**Joint Application for PSCW Certificate of Public Convenience and Necessity and
WDNR Utility Permit Badger Coulee 345 kV Transmission Line Project
PSCW Docket No. 5-CE-142**

Part 3 of the Applicants' Responses to PSCW Staff's Fifth Set of Data Requests

**PSCW Fifth Set of Request Items
Request No. 05.04 Response**

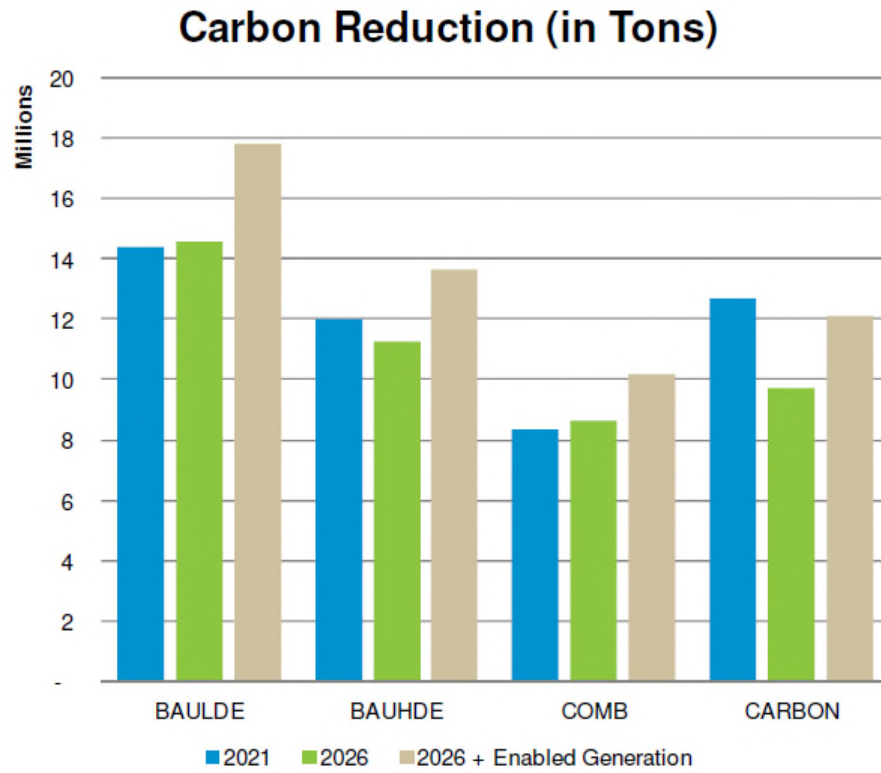
(Response to item 01.134.) Provide an updated response indicating how CO₂ emissions would change across not just the ATC footprint but MISO as well.

The following tables detail the CO₂ emissions, in tons, as taken from the 2020 and 2026 PROMOD futures for the ATC and MISO footprints both with Badger Coulee and without Badger Coulee (“Base”). The difference column (“% Change”) shows the change in CO₂ emissions when Badger Coulee is added to the model.

2020 CO ₂ Emissions (Tons)					
	ATC Footprint			MISO Footprint		
	Base	Badger Coulee	% Change	Base	Badger Coulee	% Change
Robust Economy	55,629,867	55,354,954	-0.5%	611,243,872	611,291,642	0.0%
Green Economy	49,900,305	49,787,131	-0.2%	551,106,072	551,093,620	0.0%
Slow Growth	45,756,507	45,404,809	-0.8%	473,550,999	473,563,243	0.0%
Regional Wind	44,119,826	44,145,130	0.1%	546,468,922	546,507,016	0.0%
Limited Investment	49,951,503	49,785,570	-0.3%	526,865,319	526,929,955	0.0%
Carbon Constrained	42,308,275	42,131,058	-0.4%	484,307,431	484,555,106	0.1%

The addition of Badger Coulee decreases the CO₂ emissions for the ATC footprint in five of the six futures for 2020 and in all six of the futures for 2026. The reason for this decrease is that the Badger Coulee project would increase imports (including wind generation) into ATC, which would subsequently displace fossil generation within the ATC footprint. The CO₂ impact of the Badger Coulee project on the MISO footprint is generally smaller in all futures, but shows a slight increase in emissions. This is because, as the Badger Coulee project increases imports into the ATC system, other fossil generation needs to be dispatched outside the ATC footprint to serve local needs across the system.
